Planning Commission

Regular Meeting Agenda

Frances Meaders Council Chambers
151 Willowbend Road
March 24, 2025 | 6:30 PM

SUBJECT: Conceptual Site Plan, Warehouse and Office, 1601 Moba Drive

New 403 West Park Building LL 127&130 CITY OF PEACHTREE CITY

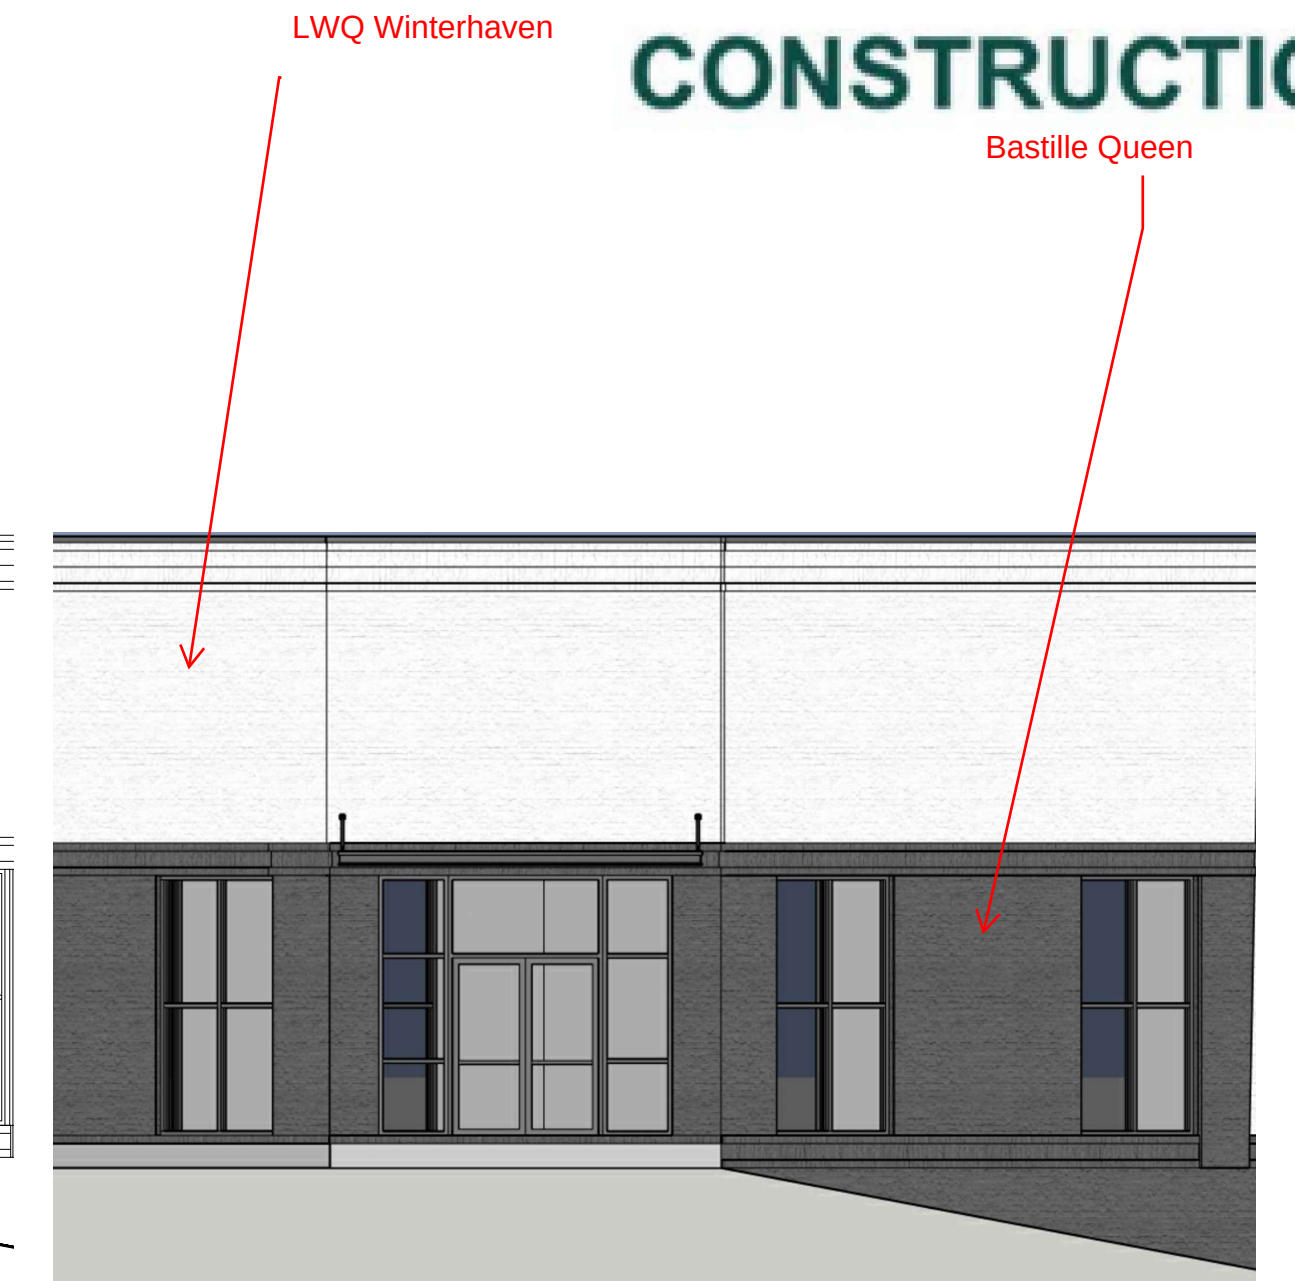
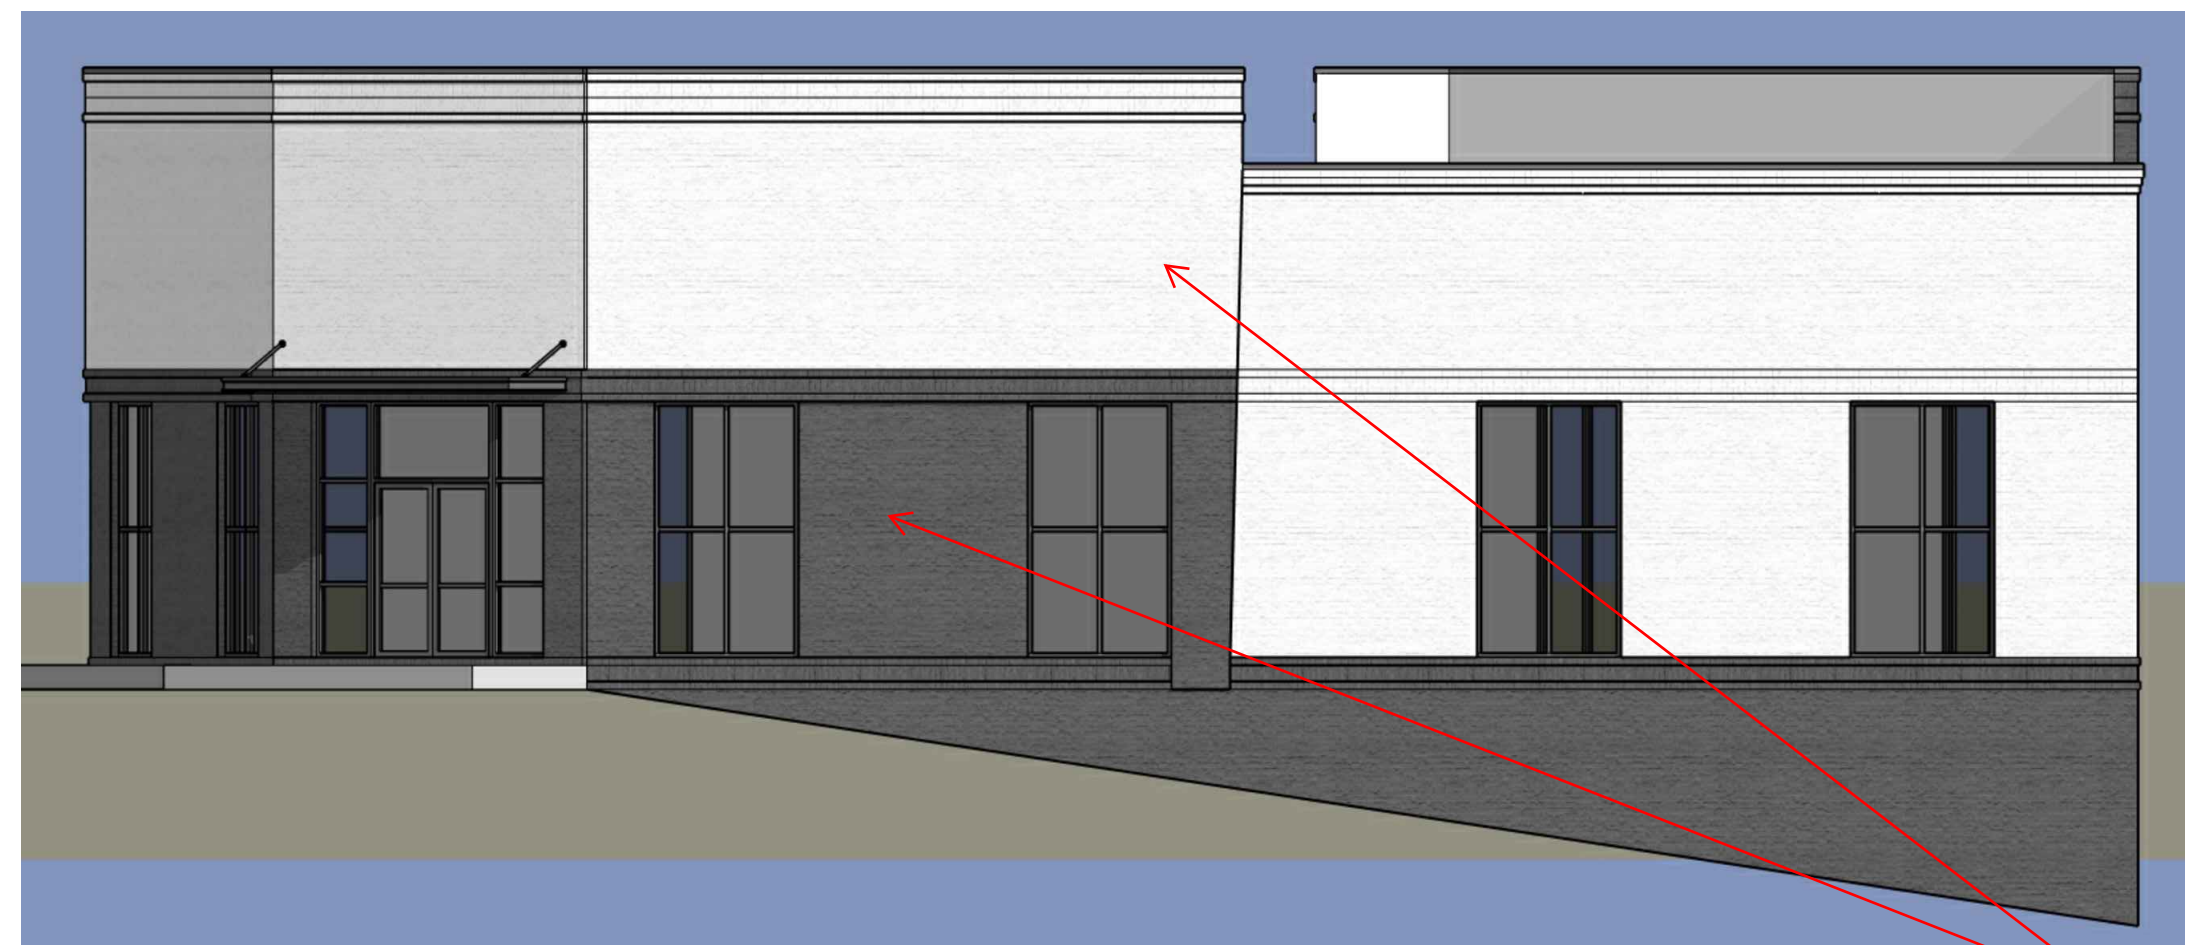
Contrasting light and dark brick is proposed on all sides of the building. Accent bands and large windows on all sides help to break up the massing of the structure and a canopy is proposed at the building entrance. The canopy, windows, and entry doors will be clear anodized aluminum.

The closest buildings include, a reddish-orange brick, light colored EIFS, and light colored brick and stone. A medium brown brick is proposed for the new Royal Condos development across the street.

Staff believes the color palette is neutral and complementary to other businesses in the immediate area and thus meets the requirements of the LDO.

New Architectural Design

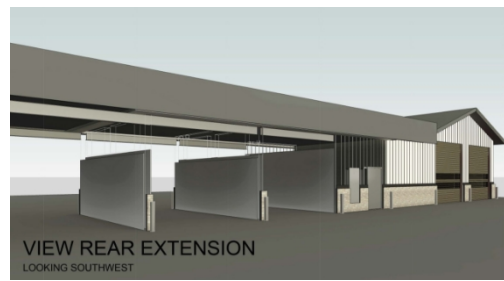
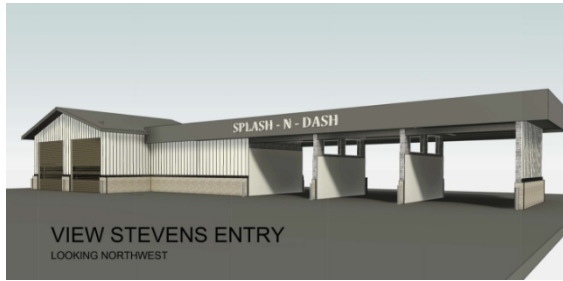
The new proposal shifts the building extension for automated wash bays to the end of the building near Prime Pt. The automated bays will occupy two of the existing bays and include an extension of 16 feet. The extended bays will have garage doors and a new, asphalt shingled, pitched roof. The remaining improvements are similar to the original design with new Hardie siding, painted brick and a stacked stone knee wall. However, a new color palette is proposed. As before, white PVC paneling is proposed inside all the wash bays for ease of maintenance.

As a general rule, front facades should be 80% primary materials and side facades 50% primary materials. Technically, the site has two fronts. Shifting the automatic wash bays to the end cap and fully enclosing them has increased the amount of primary materials. The facade facing Stevens Entry is made up of 58% primary materials, the west side facing Prime Pt. is 100%, and the east side 81%. Staff feels Hardi board is a quality durable material and meets the intent of the ordinance for primary materials.

Staff is of the opinion the new color selection is subtle and neutral and therefore satisfies the ordinance requirements.
